ARCHITECTURAL

LOGAN ELC & WELLNESS CENTER

REVISIONS
1 ADDENDUM 1 4/20/23

SPOKANE PUBLIC SCHOOL DISTRICT NO. 81
LOGAN ELC & WELLNESS CENTER
1001 E MONTGOMERY AVE, SPOKANE, WA 99207

TEMPORARY ENCLOSURE SITE PLAN

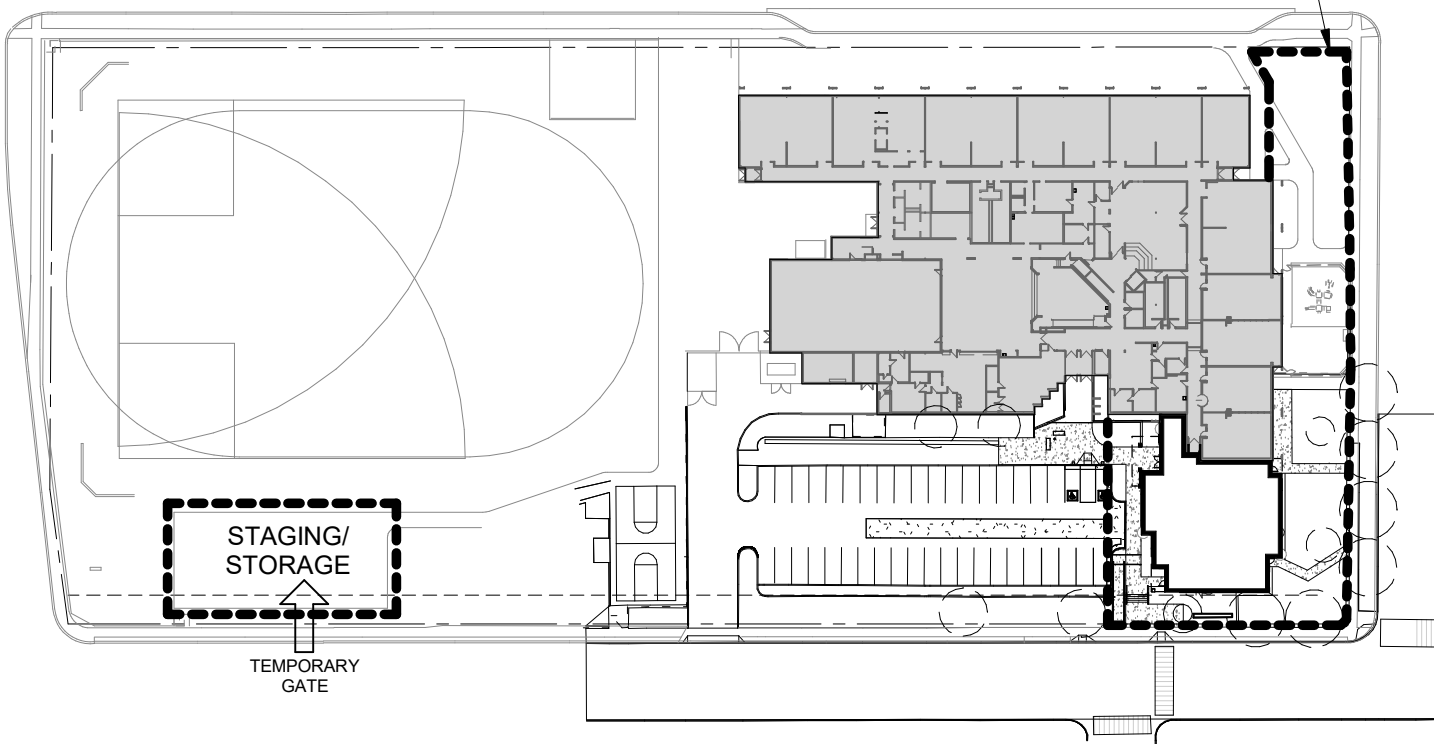
1. Article 1.9, C, 3: Add:
“b. Refer to exhibit following this Section for temporary enclosure(s) required and/or permissible around areas of Work and area for staging/storage. Temporary fencing noted thereon may be either temporary chain-link fencing or portable chain-link fencing as described in Section 015000, or a combination thereof.”
2. Insert: Drawing “Temporary Enclosure Site Plan”, copy included with this addendum, after calendars at end of Section.

LIMIT OF CONTRACTOR'S ENCLOSED WORK AREA.
SURROUND ALL AREAS OF WORK WITH
TEMPORARY FENCING AND PROVIDE TEMPORARY
GATES AS REQUIRED FOR ACCESS. RESTORE ANY
PERMANENT FENCING MODIFIED FOR ACCESS TO
ORIGINAL CONDITION AT COMPLETION OF WORK.
COORDINATE TEMPORARY INTERRUPTIONS TO
NORMAL PEDESTRIAN AND VEHICLE CIRCULATION,
AND PARKING, WITH OWNER.

UTILITY
PLAN
CD
C500

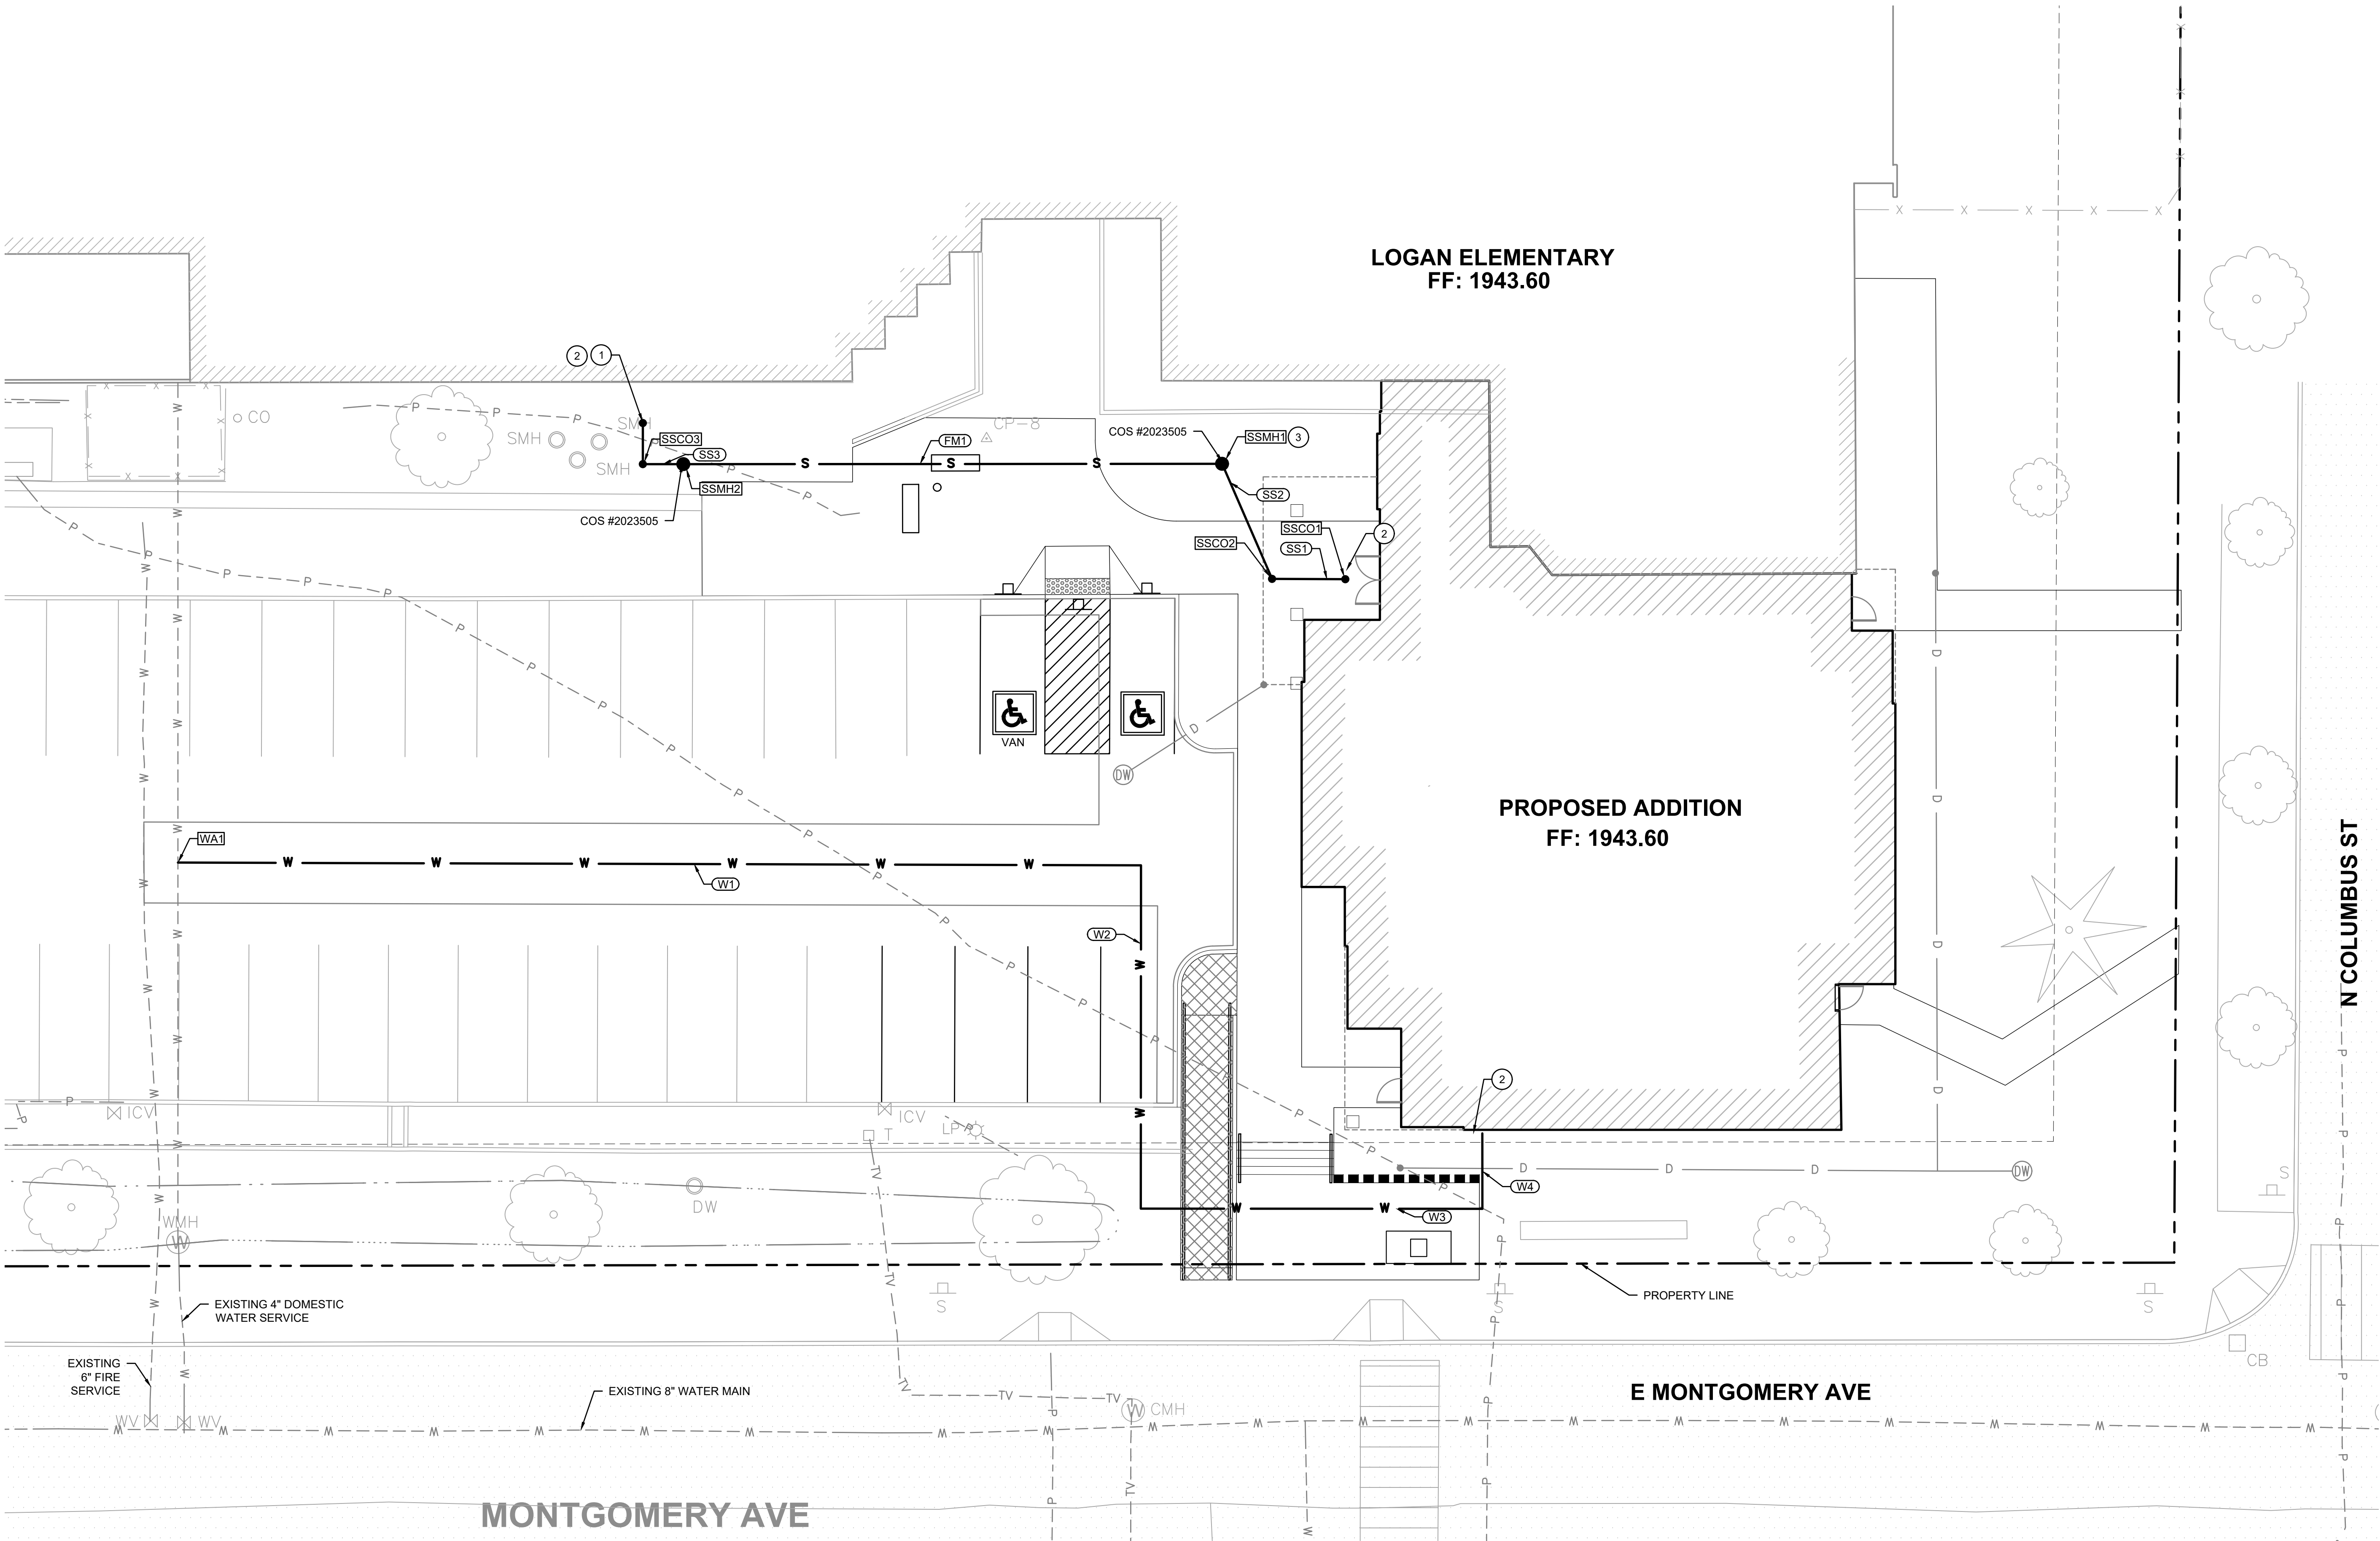
1. Revise: Pipe material of FM1. Refer to revised version of this sheet included with this addendum.

FM1	67 LF 2" HDPE @ 0.00%
SS1	9 LF 6" SDR35 PVC @ 2.00%
SS2	15 LF 6" SDR35 PVC @ 2.00%
SS3	5 LF 6" SDR35 PVC @ 2.00%

3 DISCHARGE MANHOLE
NOT TO SCALE

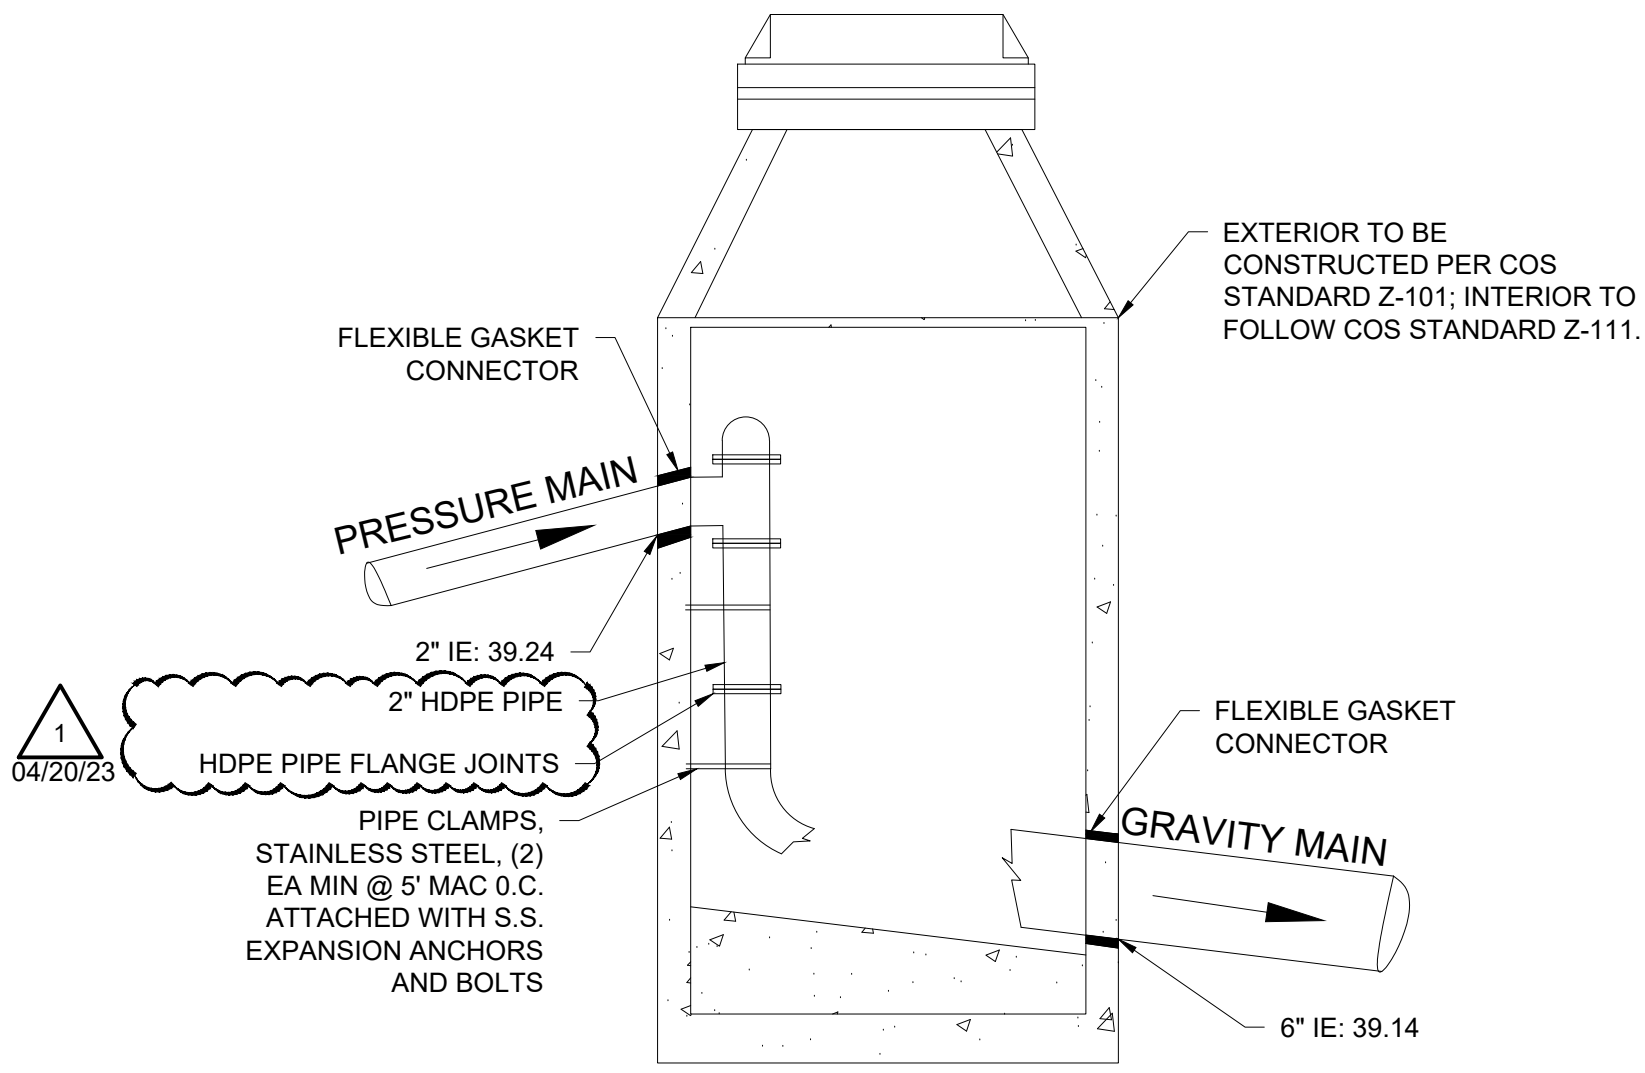
1. Revise: Labels on detail 3. Refer to revised version of this sheet included with this addendum.
